EASTSIDE COMMUNITY CHURCH ADDITION TO WICHITA, SEDGWICK COUNTY, KANSAS

RE: S/D 97-74 - One-Step Final Plat of EASTSIDE COMMUNITY CHURCH ADDITION

Re: S/D 97-74 -- One-Step Final Plat of EASTSIDE COMMUNITY CHURCH ADDITION

CASE NUMBER: S/D 97-74 EASTSIDE COMMUNITY CHURCH ADDITION

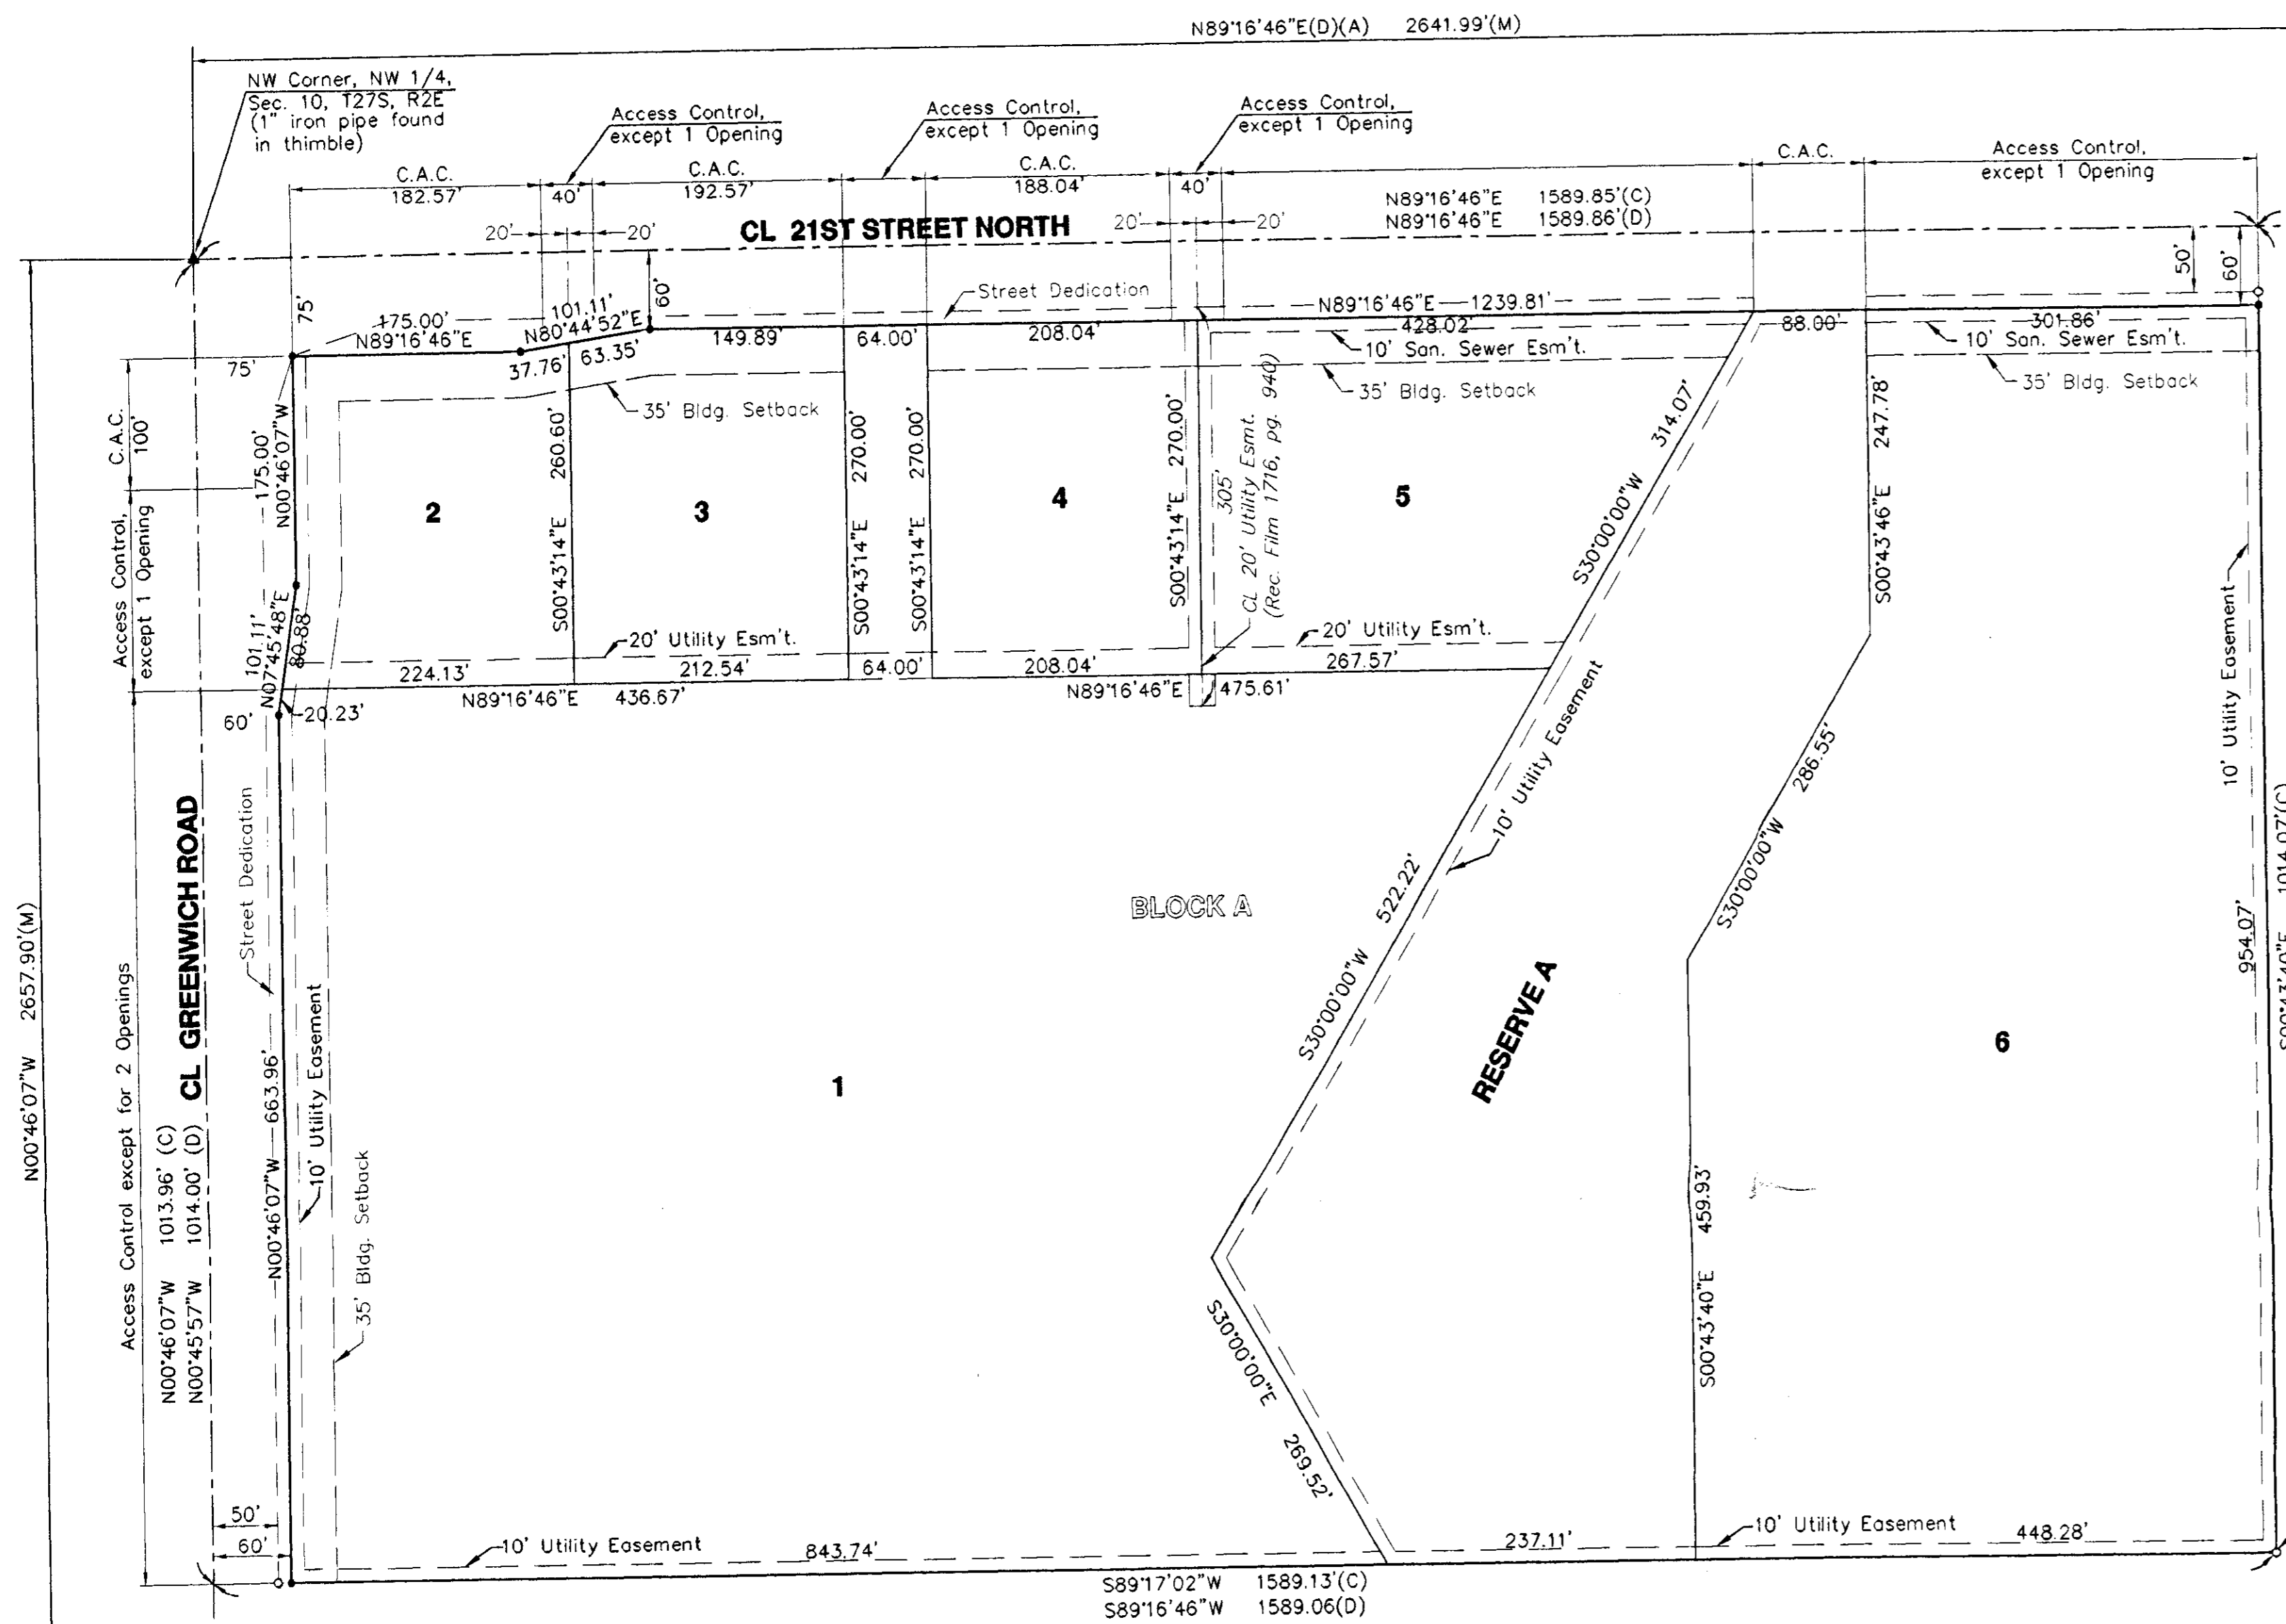
- A. City Engineering needs to indicate the requirements for the extension of sanitary sewer and municipal water to this site and what guarantees need to be provided. City Engineering has requested submission of a guarantee for extension of sanitary sewer. The 20-foot utility easement should be continuous between lots 3 and 4.
A sanitary sewer easement within Lot 6 should be denoted on the final plat for the sanitary sewer extension.

- C. County Engineering needs to comment on any traffic improvements that should be guaranteed by this plat for 21st Street North and Greenwich Road. County Engineering has requested a right-turn lane into the site from 21st Street North, applicant's participation in a city petition for a left turn lane from 21st Street North and possible participation in Greenwich Road improvements.

- L. Traffic Engineering needs to comment on the proposed access controls. The Subdivision regulations encourage shared access points for multiple lot commercial subdivisions (e.g. shared access between lots 2 and 3 and between Lots 4 and 5). **Traffic Engineering has recommended shared access points between lots 2 and 3 and between lots 4 and 5.**

- O. The representatives from City and/or County Engineering should be prepared to comment on the status of the applicant's drainage plan. Specifically, is the minimum building pad correct, and are any drainage guarantees required with the platting of this property?

- R. The applicant needs to revise the legal description to accurately portray the land being platted. The distances and degrees on the drawing must be identical to those in the legal description.

- S. On the final plat tracing, the Chairperson of the MAPC should be amended to read Richard Lopez. The Chairman of the County Commissioners should be amended to read Thomas G. Winters.

- T. For any lots with existing tree rows that may be impacted by the installation of utilities, it is recommended that overly wide utility easements (30 foot) be platted in order to allow for the installation of the utilities without damage to such tree rows.

The representative from Southwestern Bell has requested additional easements shown on the attached plat.

A drainage plan has been approved. A cross lot drainage agreement will be required.
